# United Consultants, Inc.

**Re: 70, 72, 88 and 94 East Central Street  
Site Plan and Special Permit Application Peer Review**

**Re: 70, 72, 88, and 94 East Central Street  
Site Plan Peer Review Update**

DATE	SCALE	PROJECT	SHEET
MAR. 4, 2020	1" = 20'	UC1334	6 of 9

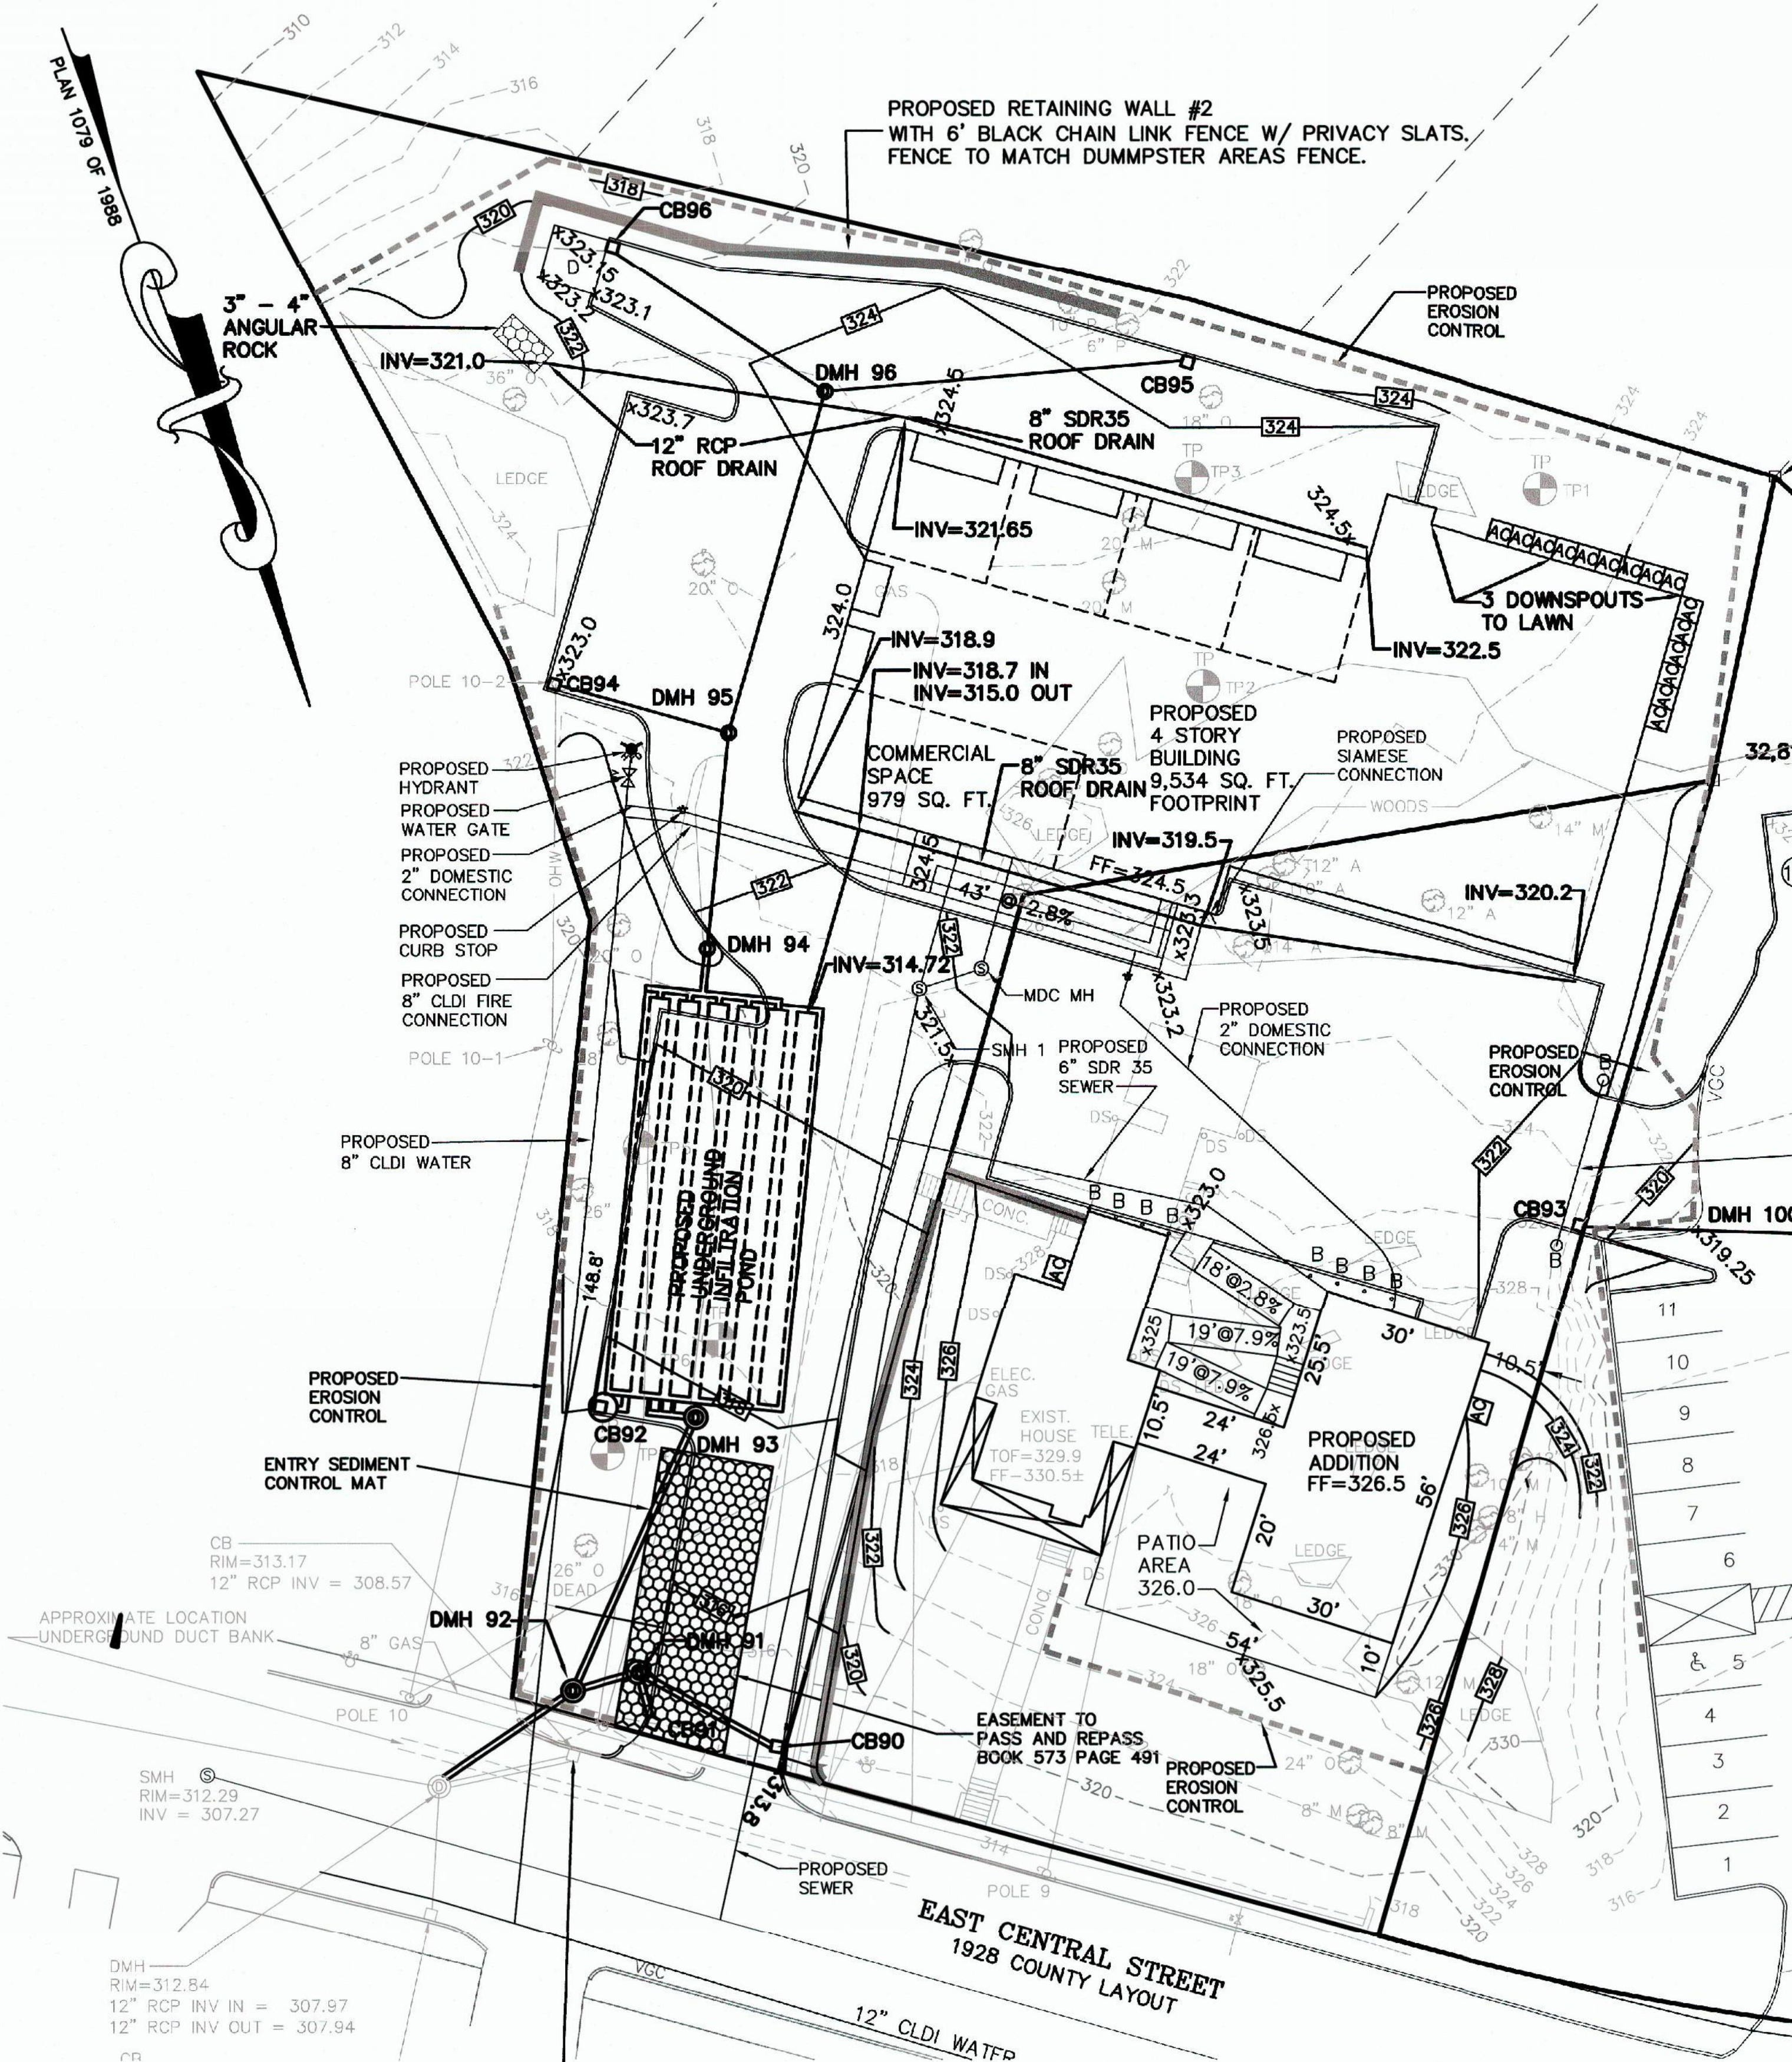
SW14. If permitted by the Town of Franklin, provide catch basin inlet protection for the catch basin located immediately east of the site entrance on East Central Street. BETA defers to the preference of the DPW on this issue.

SW15. Revise location of proposed erosion barrier along the #70/#72 property line to extend across the proposed driveway connection and to the bottom of slope on the regraded hill.

SW16. Provide erosion control barrier along the front of the #88 East Central Street property, which will have soil disturbance associated with the building addition and retaining wall.

*A note has been added. Sheet 6.*

*The erosion control barrier has been extended. Sheet 6.*

*The erosion control barrier has been added. Sheet 6.*

DATE  
**MAR. 4, 2020**  
 SCALE  
**1" = 20'**  
 PROJECT  
**UC1334**  
 SHEET  
**9 of 9**

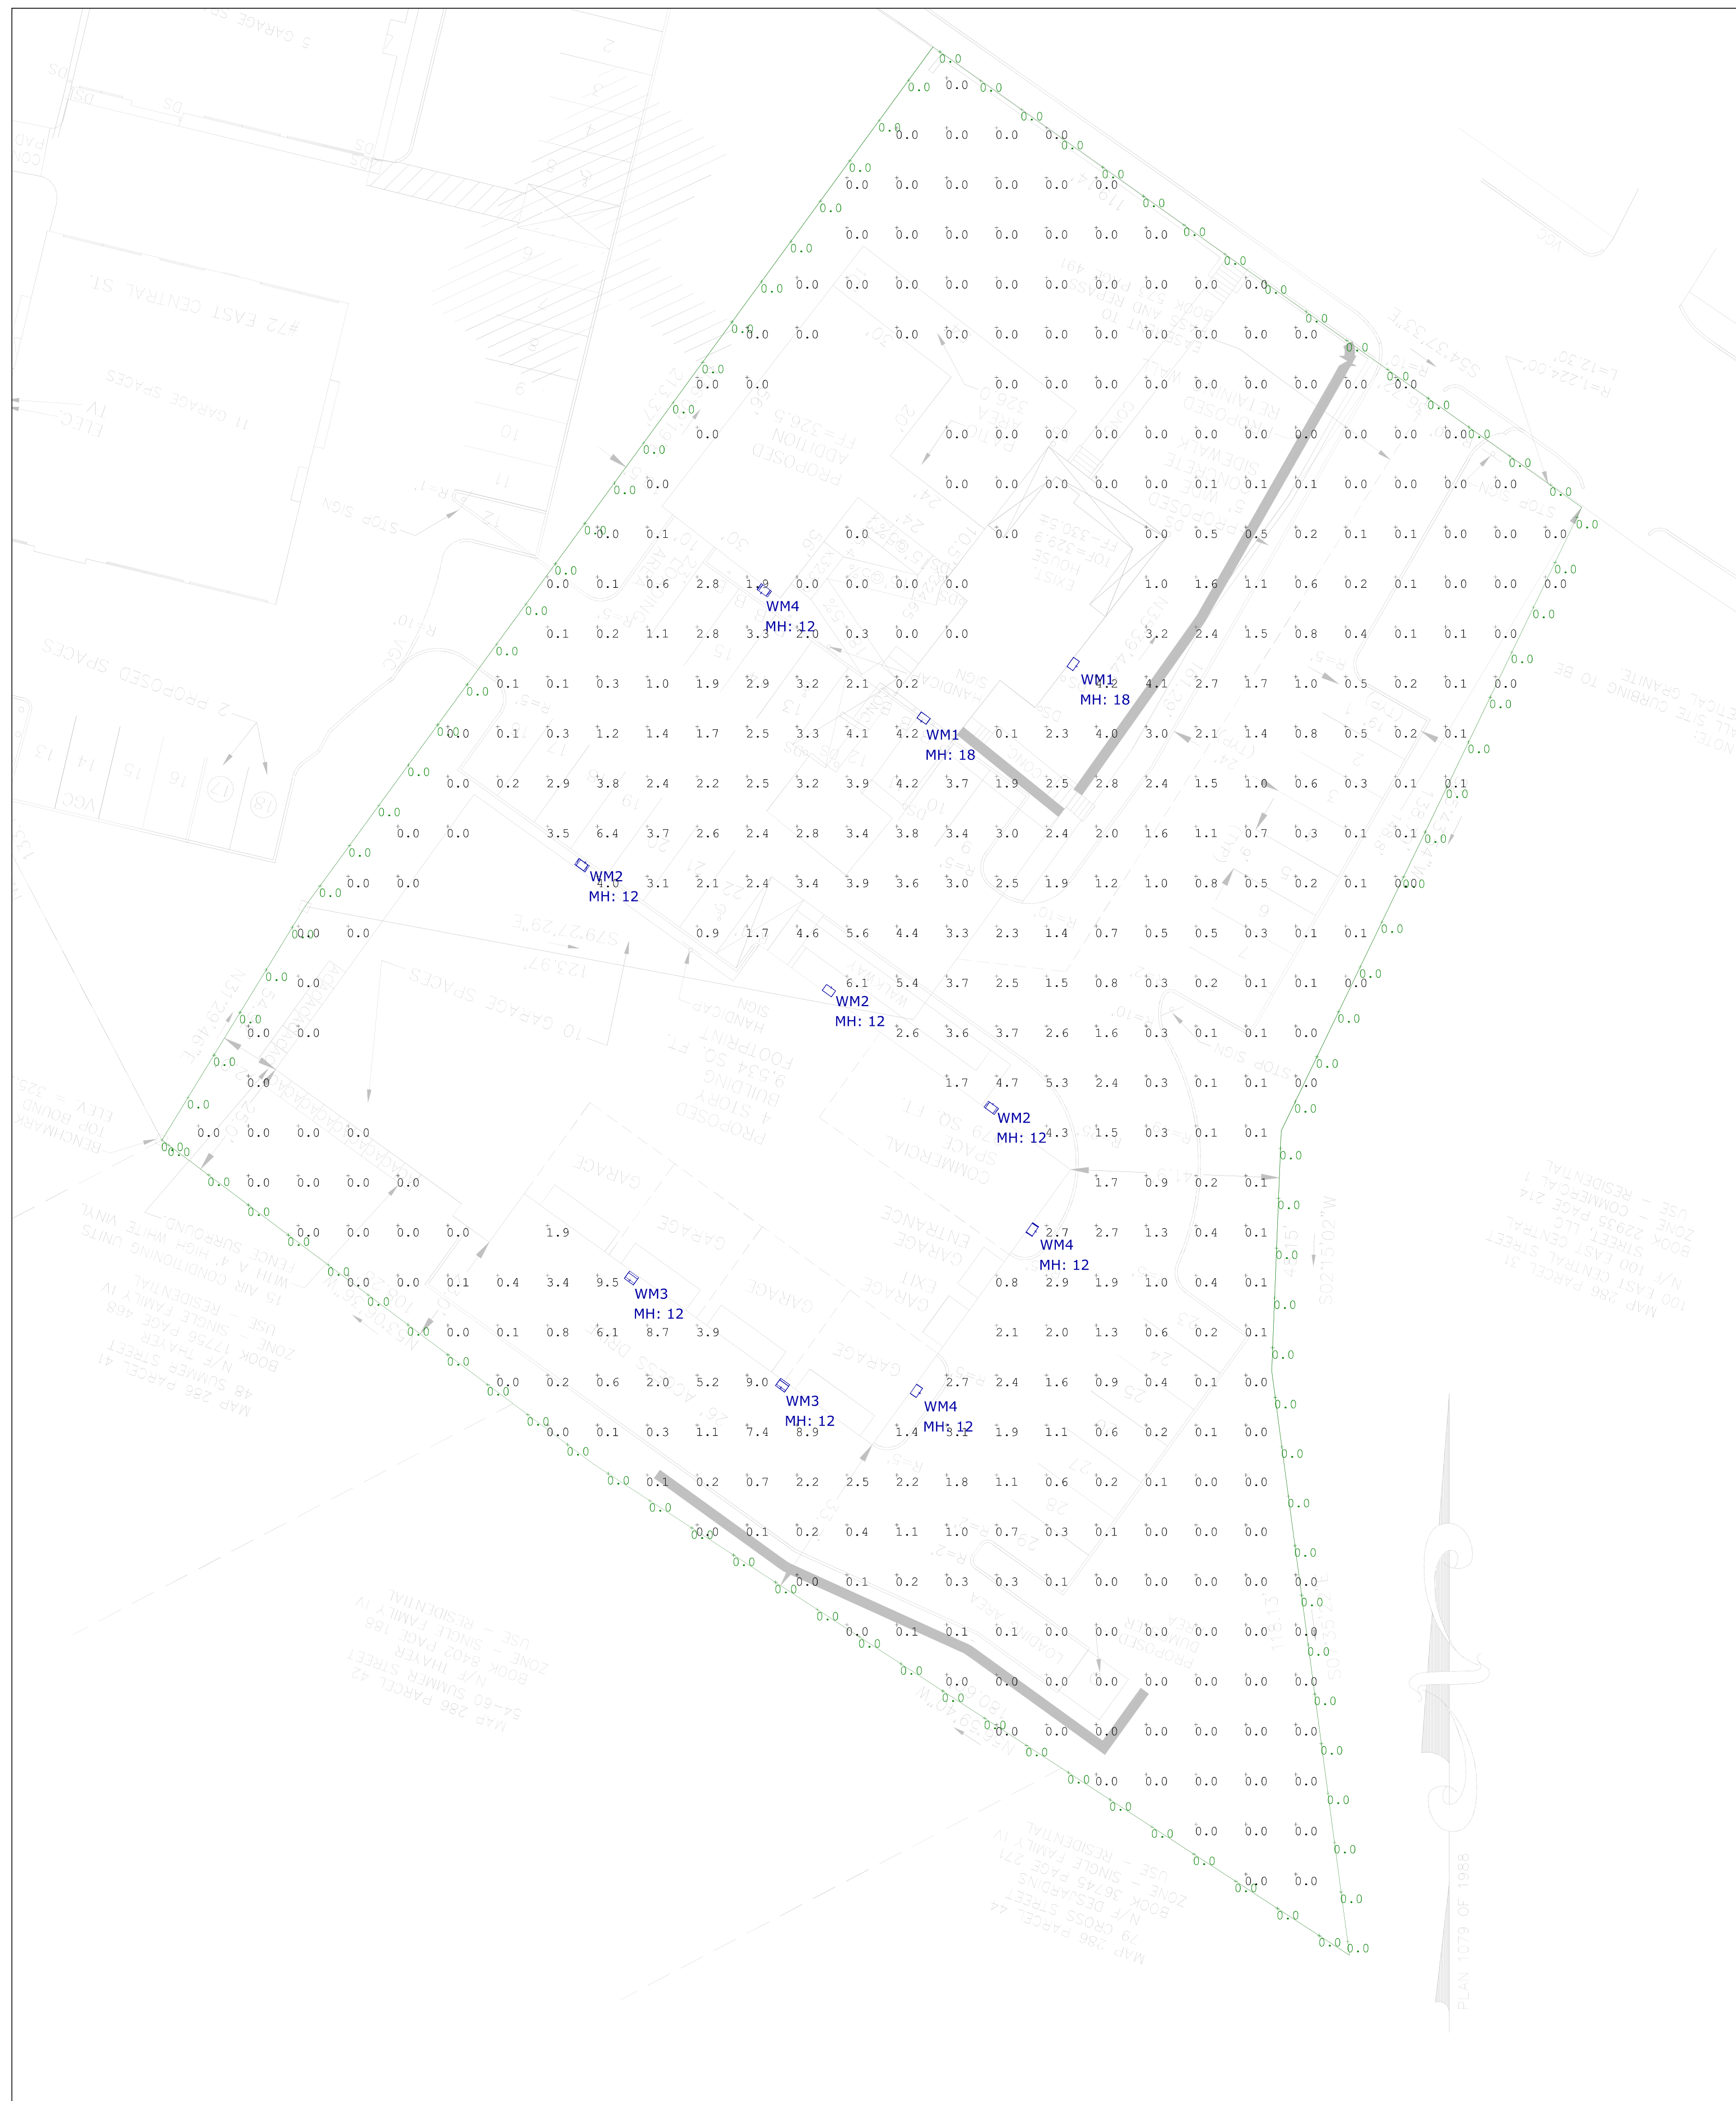
DR2. Revise the Wheelchair Ramp detail to reflect that the proposed sidewalk will be concrete.

U1. Consult the DPW and clarify how sewer lines will be connected on-site and in the Town right-of-way (e.g. tees or bends and wyes) and if any cleanouts are required.

*The wheelchair ramp detail has been revised. Sheet 9.*

*A sewer profile has been provided on sheet 9 which includes manholes at connection points from the proposed 94 building. The proposed sewer service from the proposed 88 building will include one bend*
